Report to Council Agenda item 6.2

Planning Permit Application TP-2017-188 123-127 and 129-135 Bouverie Street Carlton

12 December 2017

DELEGATED PLANNING APPLICATION REPORT

14.2.1 Building massing and setbacks

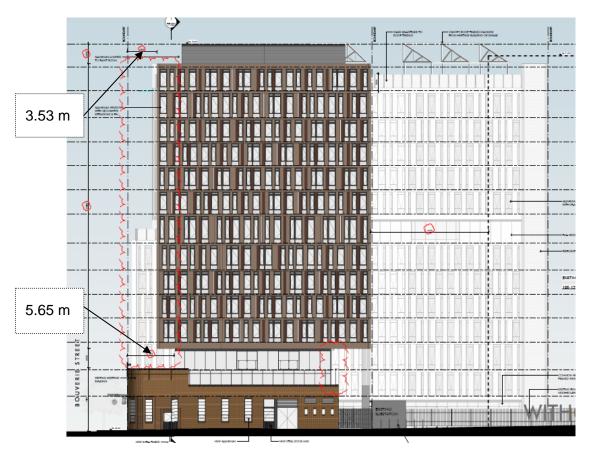
Council's Heritage Advisor did not support the initially submitted plans which proposed a very small vertical separation from the retained façade (2.34m and 1.8 m) and a shallow setback of the tower at 1 metre with zero setback to Barkly Place. A setback from Bouverie Street of 8 metres and the new southern streetwall to be at a scale consistent with the existing heritage building was recommended.

The formally substituted plans (November 2017 set) seek to reduce the impact of the new building by removing two rooms per level and increasing the setback to 3.53 metres as a consistent setback and separation of the upper form of the building from the former Modern Printing Company building. This new separation can be best seen in the image below which also demonstrates a single storey transition of 5.65 metres between the heritage building and the new building.

Typical 8.9sqm (hostel type) room

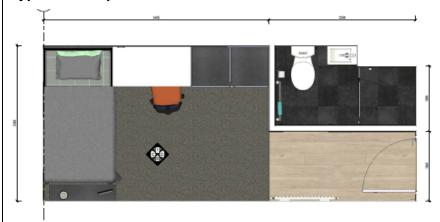
Although the 8.9sqm rooms do not meet the 10.8sqm as suggested by the policy it is considered that the increased room size (7.6sqm to 8.9sqm) would provide a similar level of internal amenity as the 10.6sqm rooms, noting that private ensuites are not proposed.

The diagrams below show that the additional area is primarily taken up with circulation space adjacent to the ensuite.

In order to achieve the desired outcomes of the policy it is considered that the shortfall of space for the 8.9sqm should be offset through the provision of extra internal communal areas. The amended plans provide an additional 668sqm of internal communal open space. The additional space ensures parity with the difference in area between the 8.9sqm and 10.6sqm rooms.
